NEWMAR CORPORATION WARRANTY DEPARTMENT

TECHNICAL SERVICE BULLETIN							
DATE ISSUED	MODEL YEAR(S) AFFECTED	MODEL(S) AFFECTED	TSB #				
05/17/01	1996-2001	ALL	219				
BRAND		TYPE					
All <input checked="" type="checkbox"/>	American Star <input type="checkbox"/>	Kountry Star <input type="checkbox"/>	Dutch Star <input type="checkbox"/>	All <input checked="" type="checkbox"/>	T T <input type="checkbox"/>	F W <input type="checkbox"/>	
NewAire <input type="checkbox"/>	Mountain Aire <input type="checkbox"/>	Kountry Aire <input type="checkbox"/>	London Aire <input type="checkbox"/>	C A <input type="checkbox"/>	D P <input type="checkbox"/>	D B <input type="checkbox"/>	
<input checked="" type="checkbox"/> Air Conditioning & Heating				<input type="checkbox"/> Electrical Components			
<input type="checkbox"/> Appliances & Accessories				<input type="checkbox"/> Exterior Components			
<input type="checkbox"/> Cabinets & Furniture				<input type="checkbox"/> Interior Components

TSB #219

Air Conditioner Sealing Gasket Front of Unit

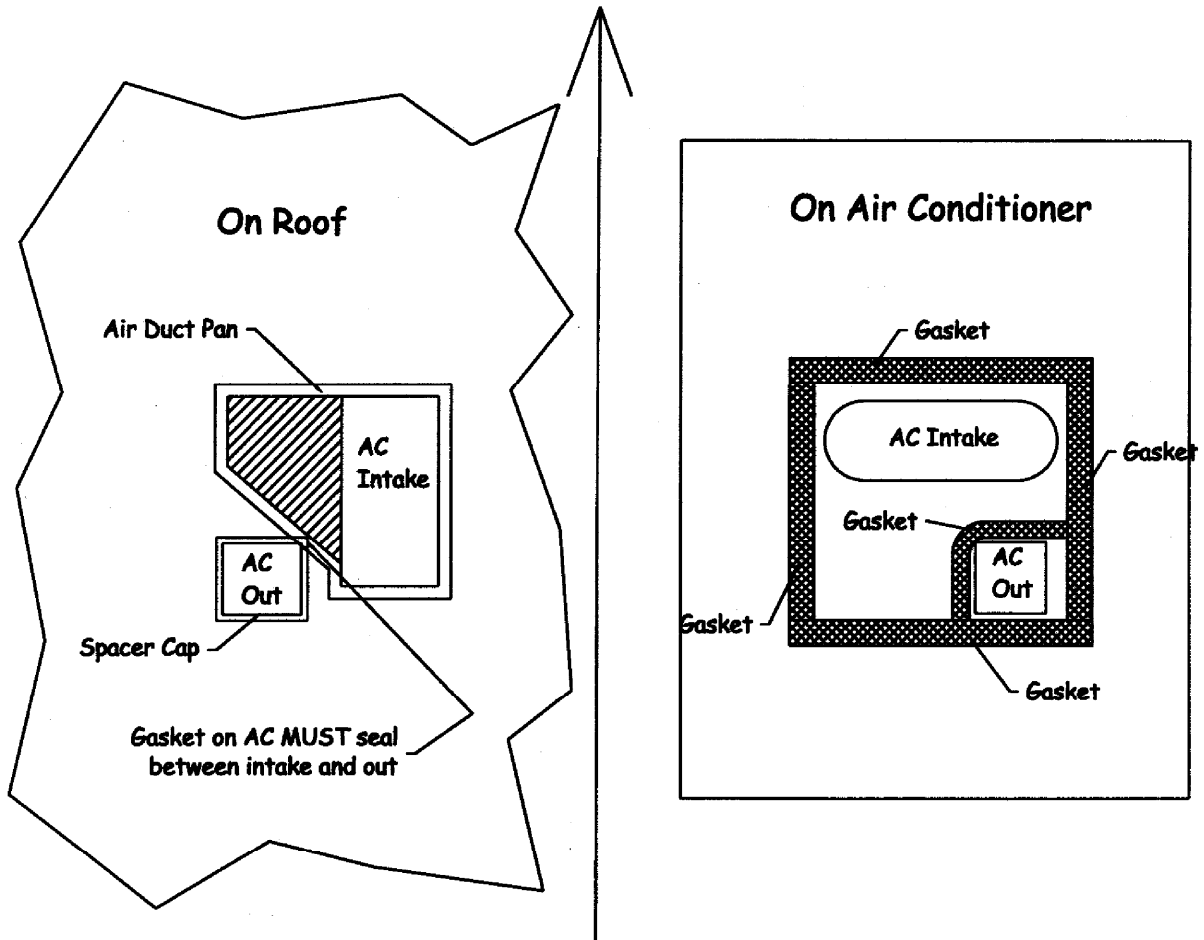
<input type="checkbox"/> Chassis Components				<input type="checkbox"/> Plumbing & Bath Components			
<input type="checkbox"/> Construction Components				<input type="checkbox"/> Windows, Awnings, Vents, & Doors			
DESCRIPTION OF PROBLEM							
Newmar is finding that roof A/C gasket installation work in the field is not being re-installed properly causing the A/C to freeze up.							
RECOMMENDED SOLUTION							
Install the perimeter gasket, along with a secondary gasket, to seal the output area from the intake area. Please see the attached drawing and if you have any questions, please call a Newmar representative.
